Number: # SI-887-R0

Plate Details for Mechanical Cores

HUMBER RIVER REGIONAL HOSPITAL PROJECT NAME:

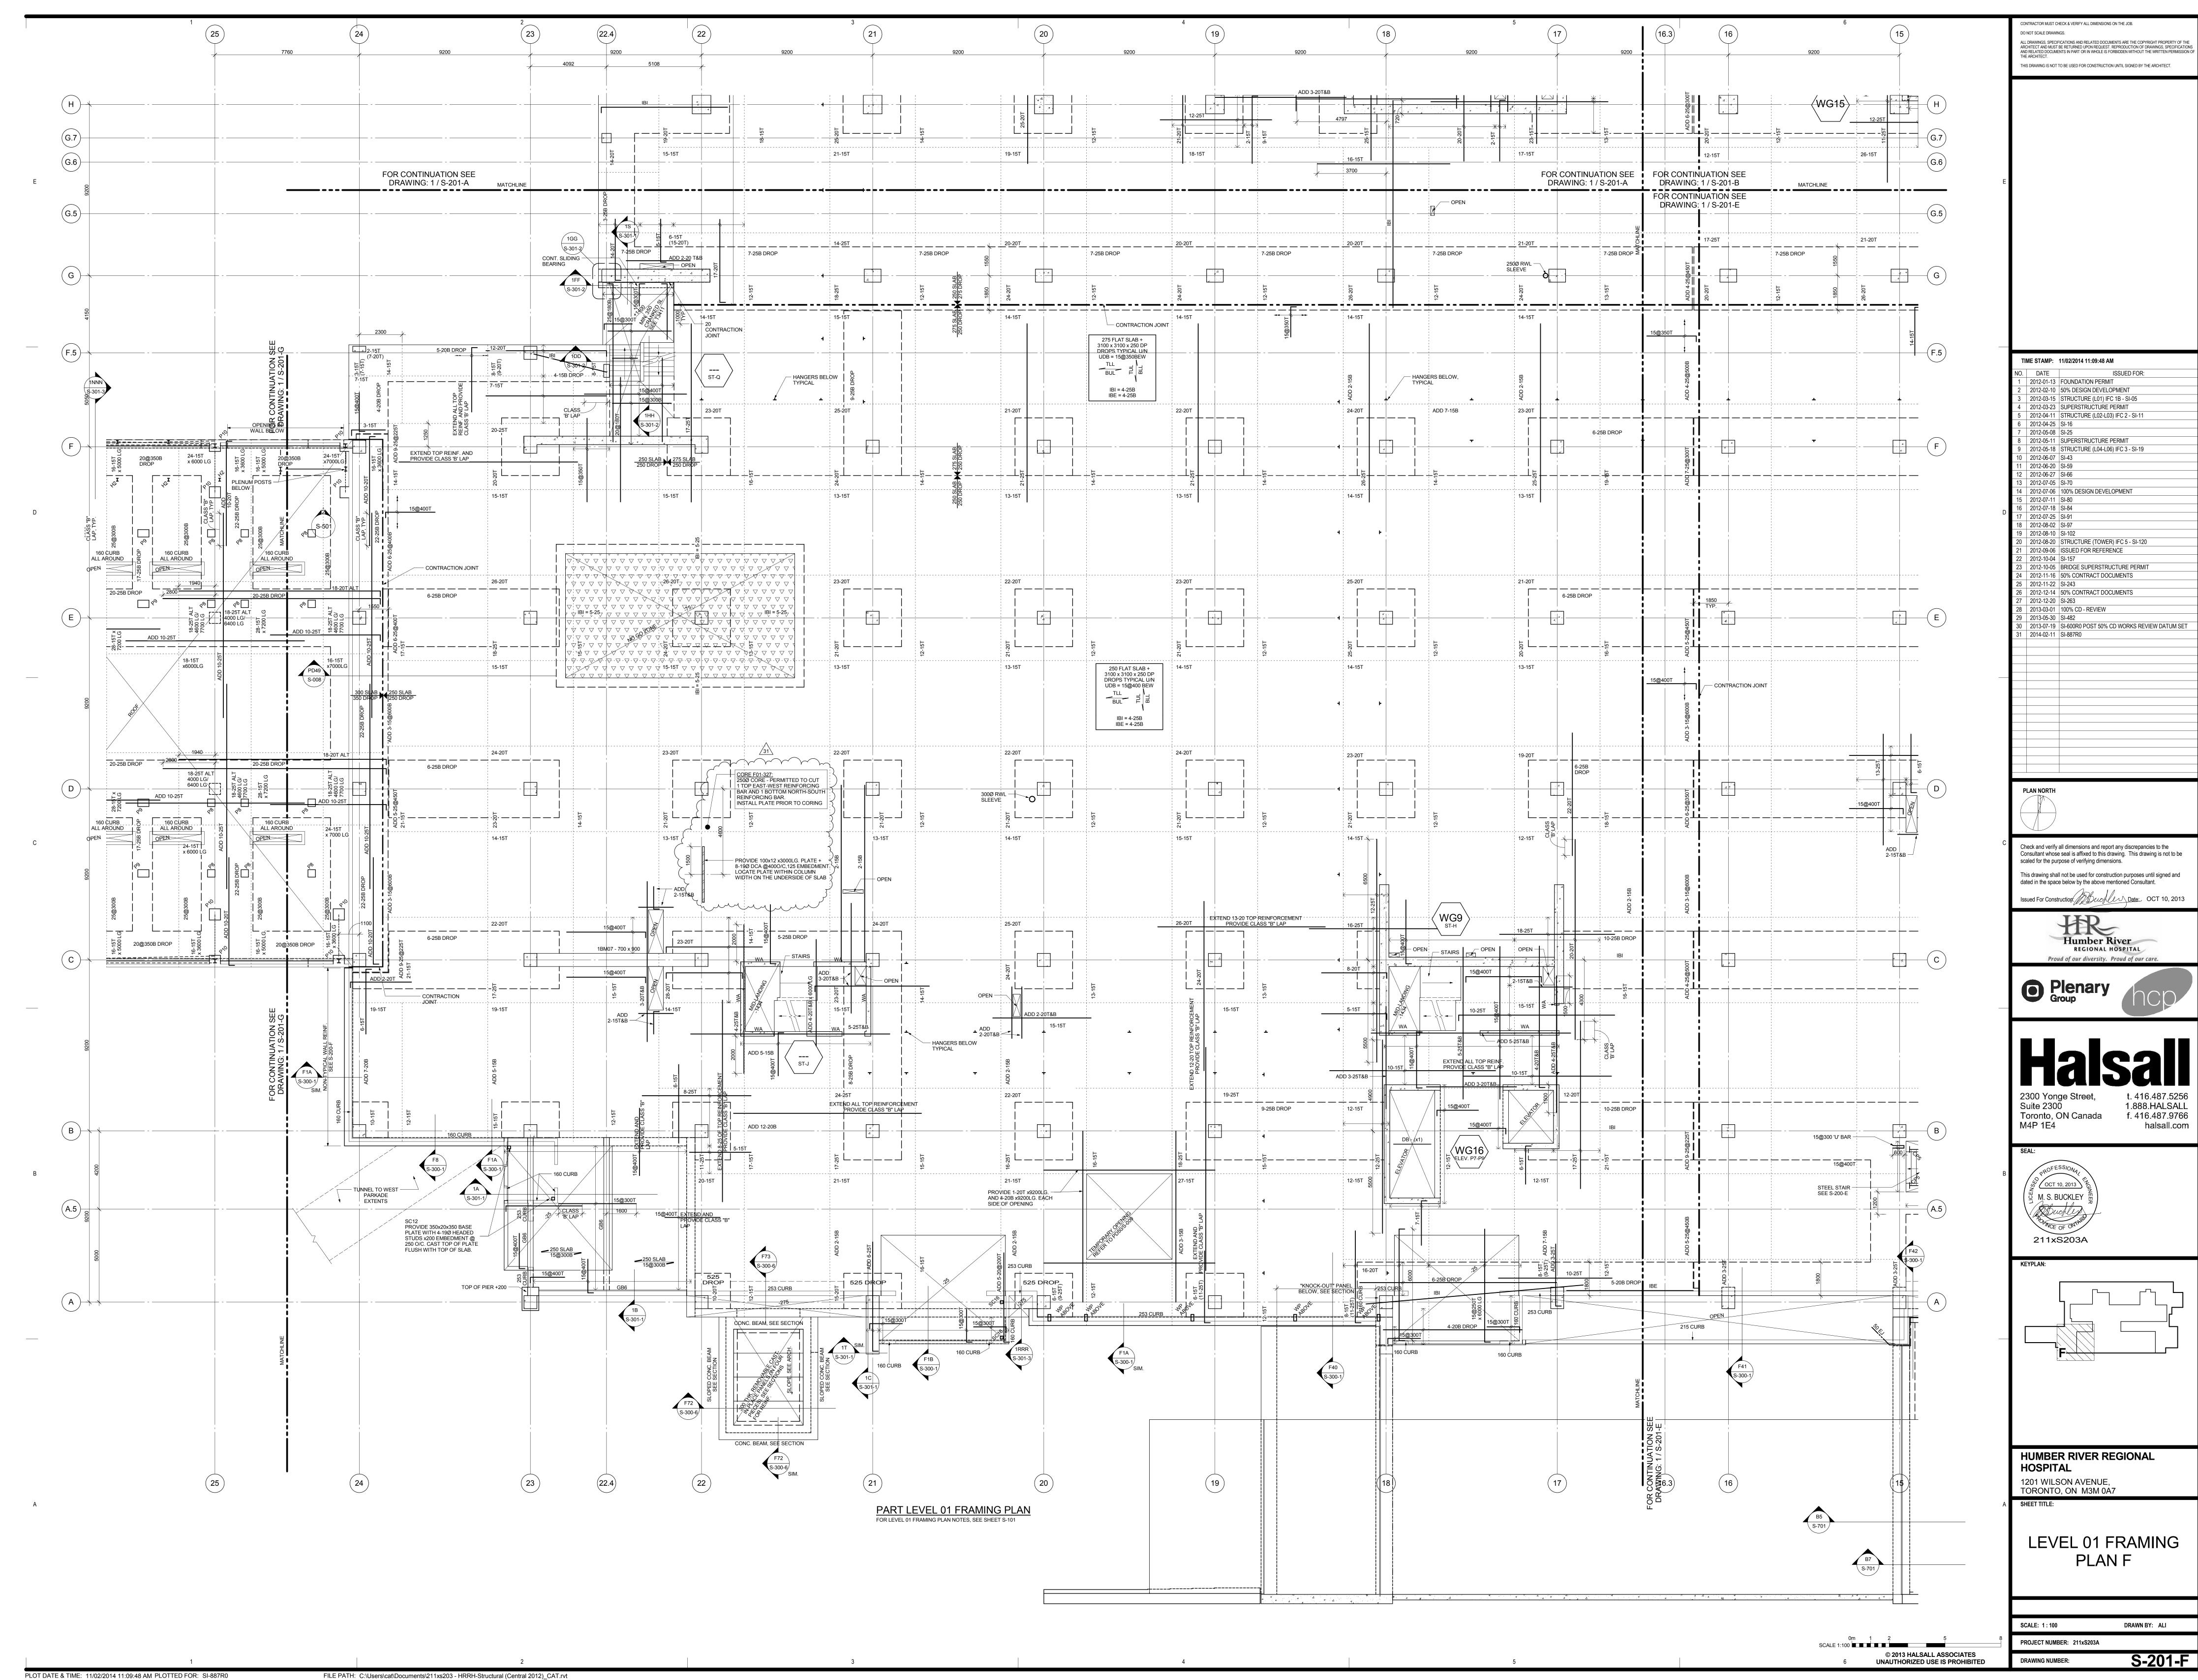
887R0.1	S-201-F, S-202-B, S-206-B, S-302-2	Added plate details required to be installed on the underside of structural slabs at various locations. Refer to attached drawings, changes are clouded.
		Reason: Structural requirement due to mechanical cores through slabs required in locations that will cut slab reinforcement.
